SERVICE BULLETIN SB FSG2T-1.06

TYPE DESIGNATION FSG 2T VHF/AM Airband Transceiver – Part number F10350

REASON Possible degradation of operational availability could create disruption of VHF communication due to internal capacitor misplacement. The capacitor could be destroyed and could be separated with possible generation of smoke.

Fig. 1: TX/RX Module with misplaced Capacitor C2038

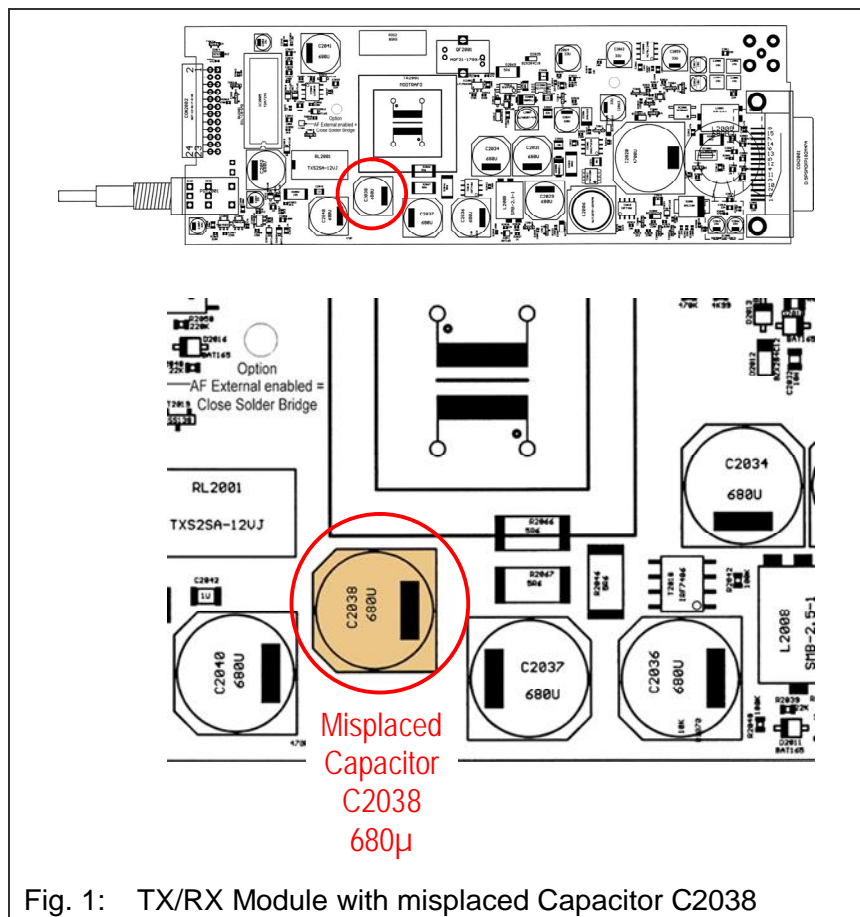
DESCRIPTION Replace the misplaced capacitor by a new capacitor placed as shown in the attachment. To have access to the capacitor it is necessary to open the unit and to separate the TX/RX Module from the Chassis. Remove the adhesive fixing and replace the SMD capacitor.

Locate the misplaced capacitor C2038 (680 μ) on the TX/RX Module.

Fig. 3: Position of Mod-Index Label

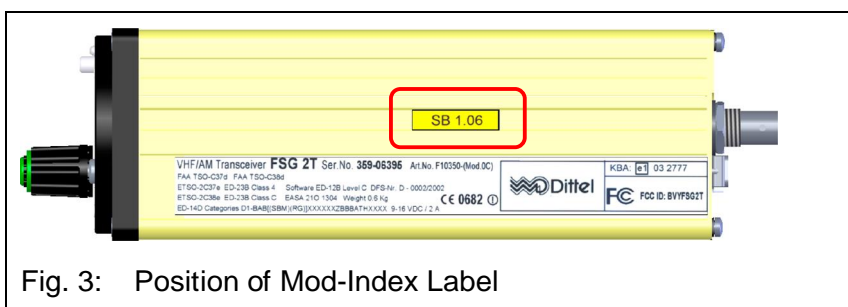
After meeting the required minimum performance values mark the transceiver FSG 2T with the supplied Mod-Index label

SB 1.06
